Subject: FCC ID: MAU030

Image 1

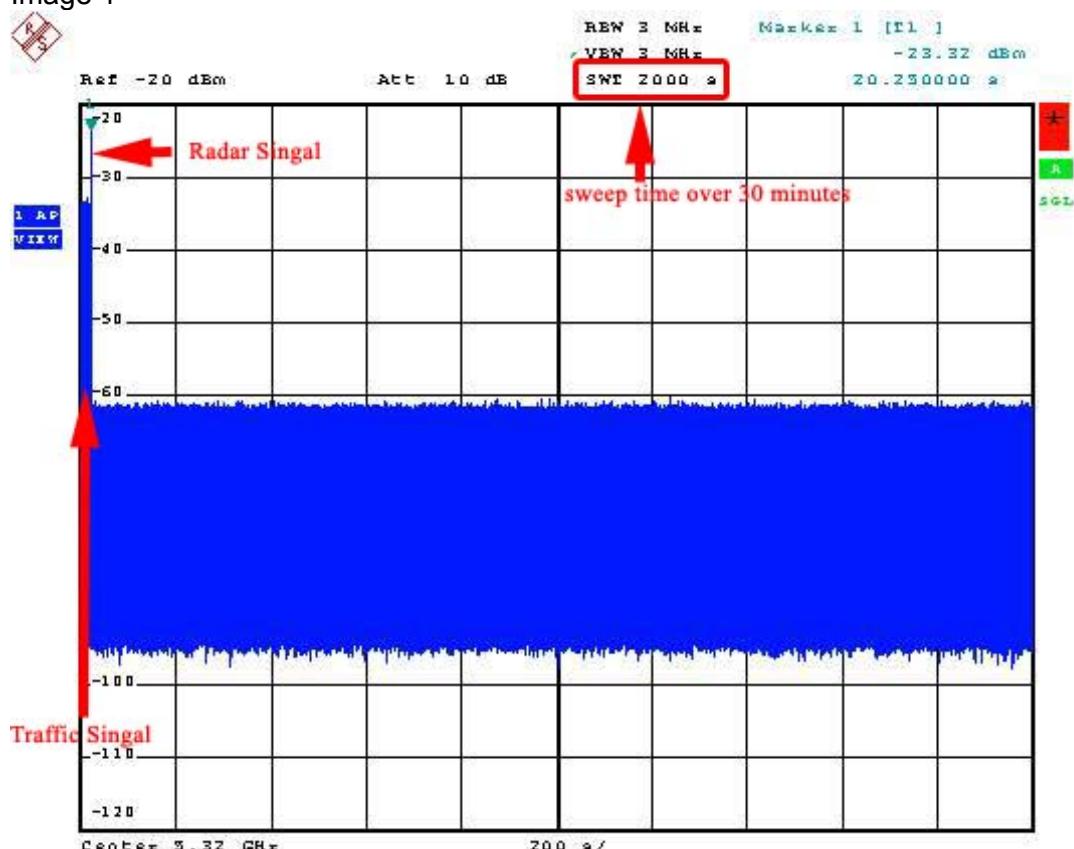
17) FCC has recently been asking for the following additional test: Client devices - Test client devices to ensure that they comply with the 30 minute non-occupancy requirement for a channel after moving off of a channel when radar is detected. Some clients will send beacons on a channel that is supposed to be cleared for 30 minutes. This non-occupancy test was not required in the original test procedure as published. FCC is requiring the test to be conducted effectively immediately (August 14, 2007 TCB Conference Call). TCBs must check for this requirement before grant. This test does not appear to be performed.

Ans: We take a image capture from spectrum for sweep time 2000 seconds (Image 1) to monitor the connection. The device was complied with the 30 minute non-occupancy requirement for a channel after moving off of a channel when radar is detected. And we prepare the other image (Image 2) capture from web form of the support access point (Cisco 1240AG) for your reference.
